**Report: Punch list**  
**Function: Test, Adjust, & Balance**  
**Date: 11/05/2025**  
**Completed By: National TAB**

**11-03-25 Freddys - Versailles, KY**

Project: 11-03-25 Freddys - Versailles, KY

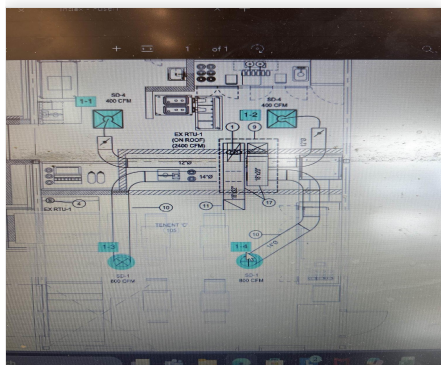
**Issue Name :** Hood HMI not functioning properly  
**Description :** HMI controls both hoods with a single speed. They cannot be controlled independently of each hood. DRD mechanical wasn't to adjust speed.  
**Created By :** National TAB **Assigned To :** National TAB - Dan Hertenstein  
**Status :** Open  
**Priority :** High **Asset Tag :** HVAC EQUIPMENT1  
**Originated Date :** 11/05/2025 - Jearod Ferrette - National TAB
